STATE OF CONNECTICUT  
CONNECTICUT SITING COUNCIL

IN RE: :  
 :  
APPLICATION OF HADDAM QUARTER : DOCKET NO. 505  
SOLAR, LLC FOR A CERTIFICATE OF :  
ENVIRONMENTAL COMPATIBILITY AND :  
PUBLIC NEED FOR THE CONSTRUCTION, :  
OPERATION AND MAINTENANCE OF A :  
2.8 MW/AC SOLAR PHOTOVOLTAIC :  
PROJECT OFF HADDAM QUARTER :  
ROAD AND JOHNSON LANE IN :  
DURHAM, CONNECTICUT : SEPTEMBER 9, 2021

RESPONSES OF HADDAM QUARTER SOLAR, LLC  
TO CONNECTICUT SITING COUNCIL INTERROGATORIES

SHEET TITLE:  
**OVERALL LOCUS MAP**  
 SHEET NUMBER:  
**OP-1**

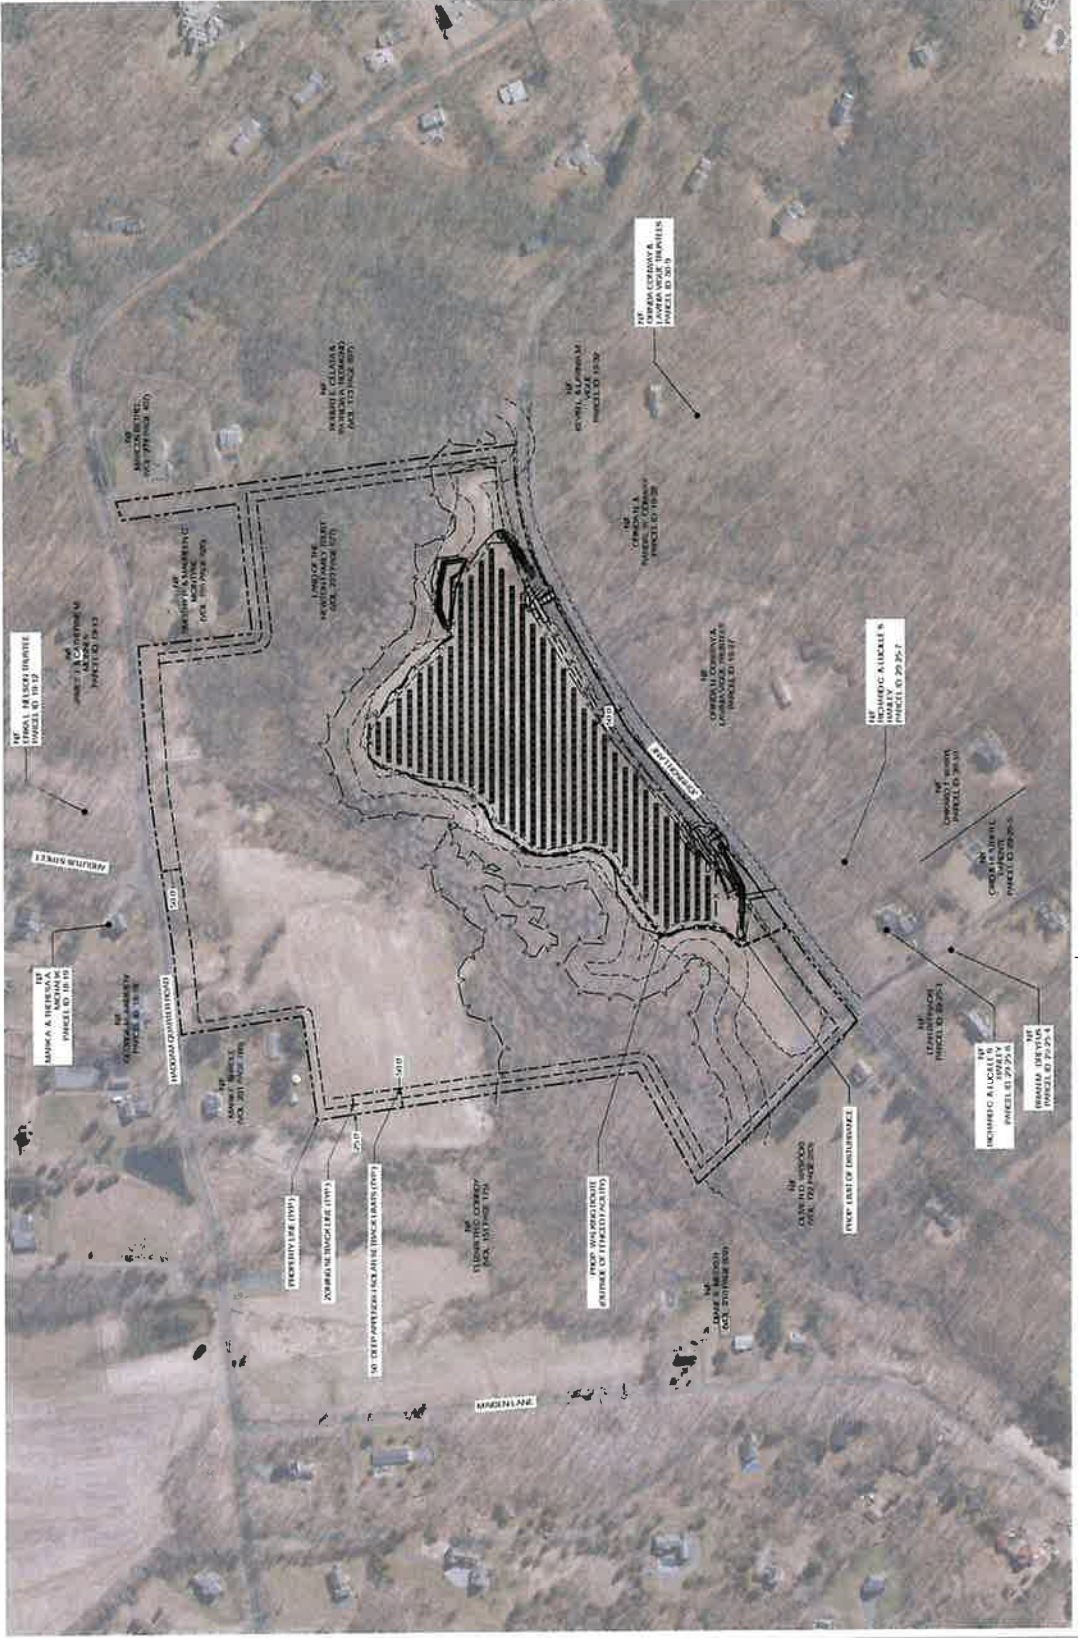
Referring to Site Plan OP-1, what is the width of the wetland buffers shown on the plan?

The wetland buffers depicted on Site Plan OP-1 are 50 feet and 100 feet. These buffers also comply with the requirements of the DEEP stormwater general permit (Appendix I).

SHEET TITLE:  
**FINAL GRADING & DRAINAGE PLAN**

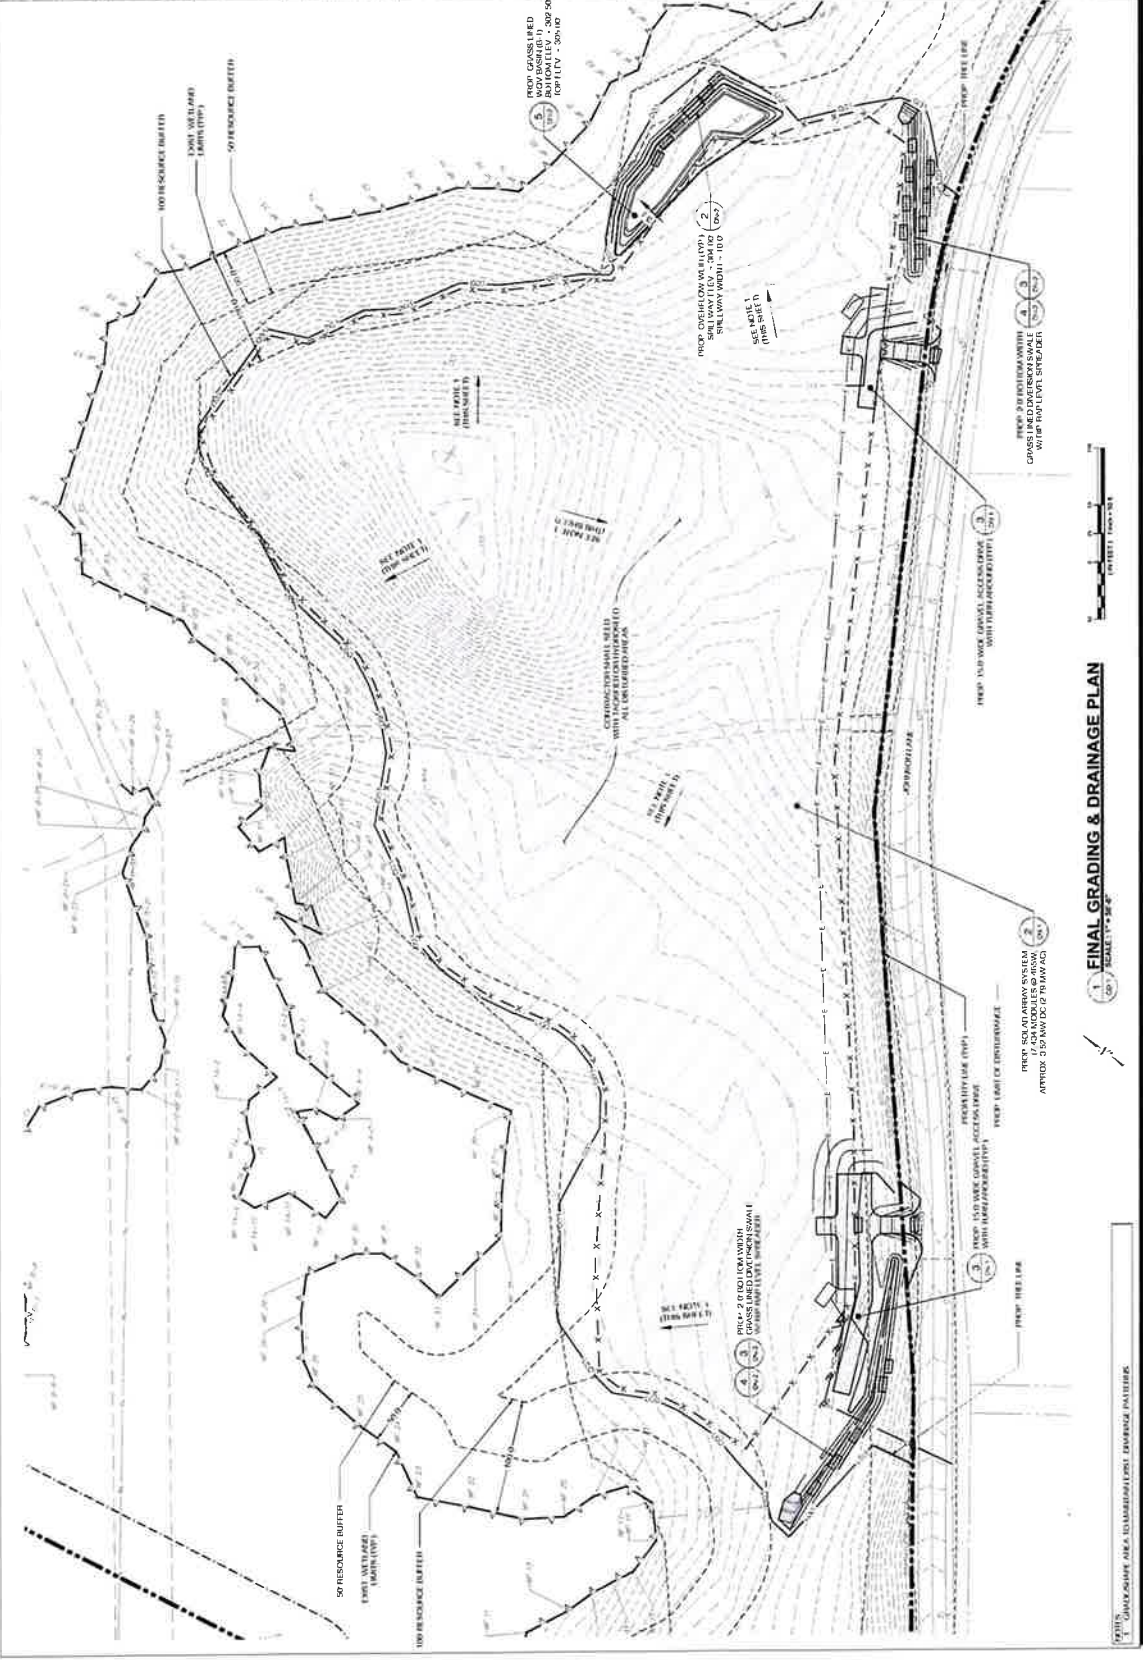
Referring to Site Plan GD-1, Note 1, what areas need to be re-graded?

Note 1 is intended to emphasize to the Applicant's contractor that, if any grading/shaping that is not shown as part of the grading plan occurs, it must maintain existing drainage patterns.

**SHEET NUMBER**  
**SP-1**

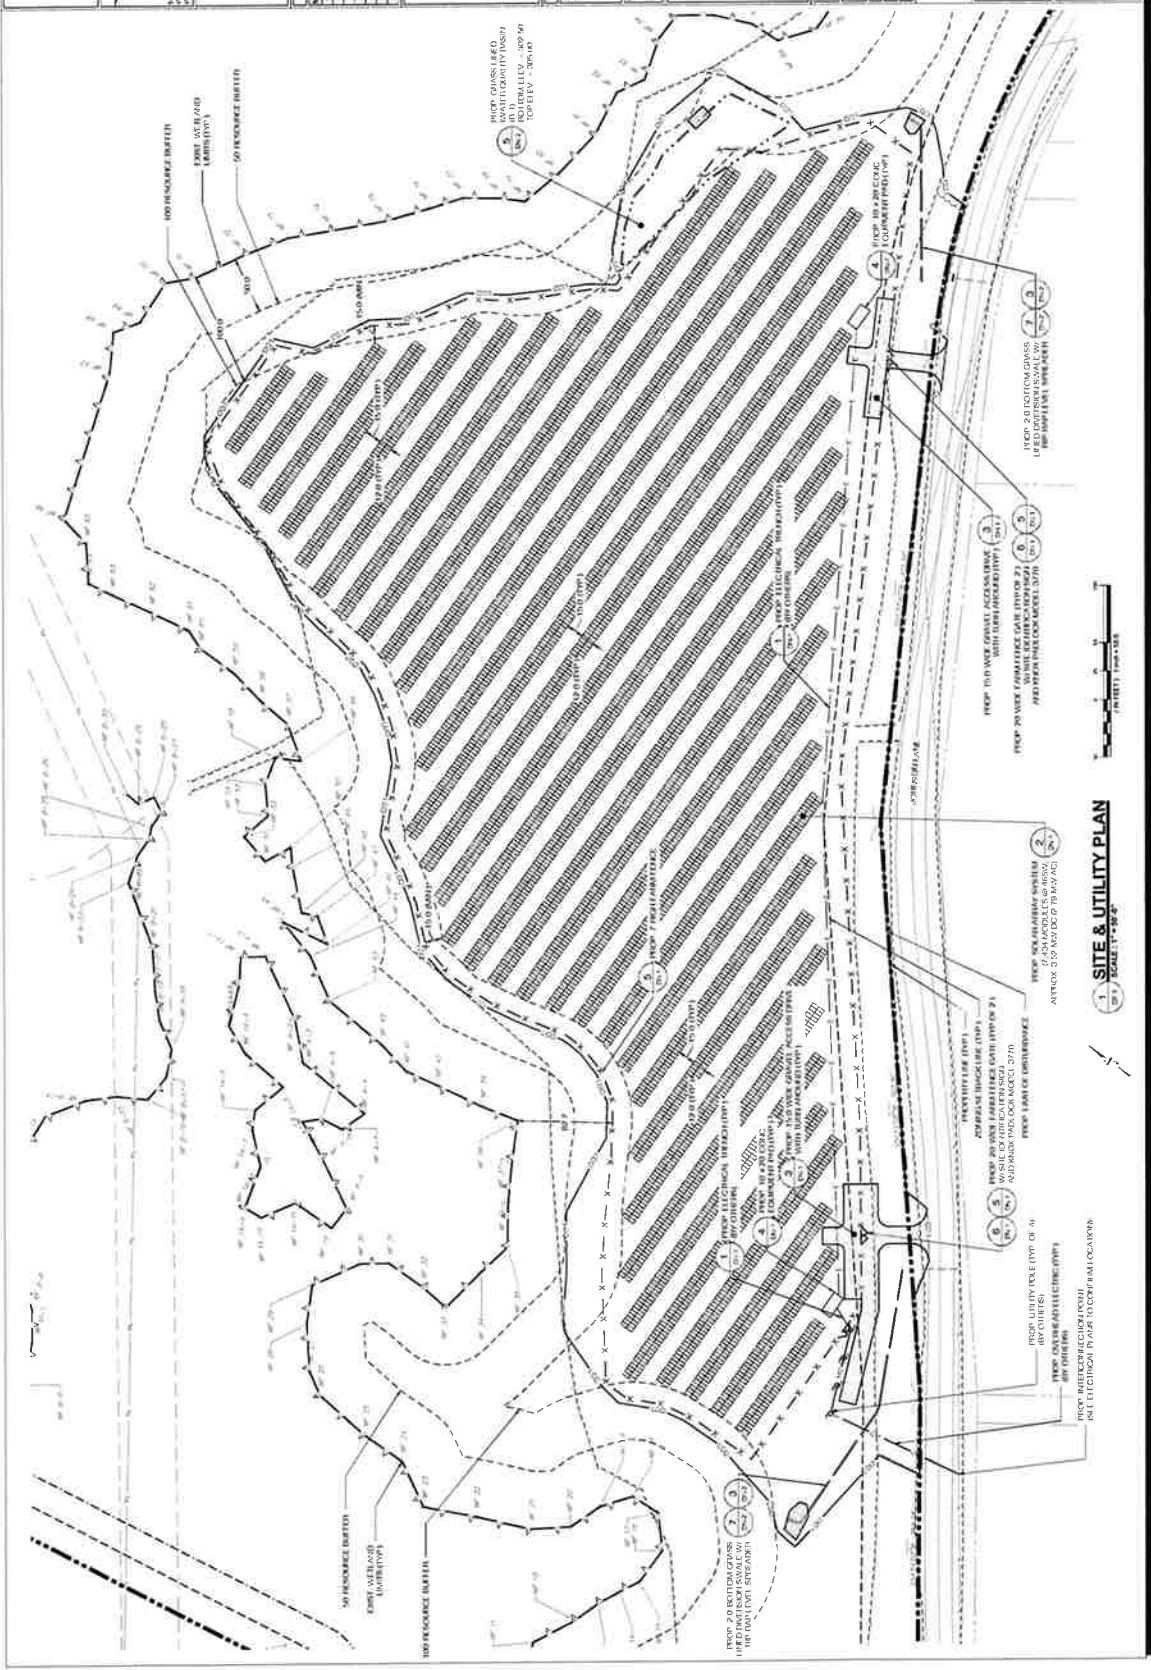
Thank you for the electronic file to review of the proposed Haddam Quarter Solar Farm. One item of interest I found are the comments on the site and utility plan Sheet SP-1 which stated:

- PROP. OVERHEAD ELECTRIC (TYP.) (BY OTHERS)
- PROP. INTERCONNECTION POINT (SEE ELECTRICAL PLANS TO CONFIRM LOCATION)

I've checked on the CSC Docket 505 site for said Electrical Plans but found none.

Since both of these items directly tie into an Eversource pole (not noted on the Preliminary / Progress Plan on Sheet V-1) at the front of my 119 Johnson Lane property, I'd like to know more about them and what they will look like.

I heard back from my client and their project engineer regarding your most recent questions. It is important to note that the interconnection for the proposed solar facility will be owned and controlled by Eversource. The final electrical plans will be developed by Eversource following the approval of the project by the Siting Council.

That said, the plan, as proposed by Louth Callan Renewables (Haddam Quarter Solar), is to install four Class 2 wood utility poles like the one shown in the attached photograph, all located in the far-westerly portion of the project area. The pole locations are shown on plan sheets OP-1, GD-1, SP-1 and LP-1.
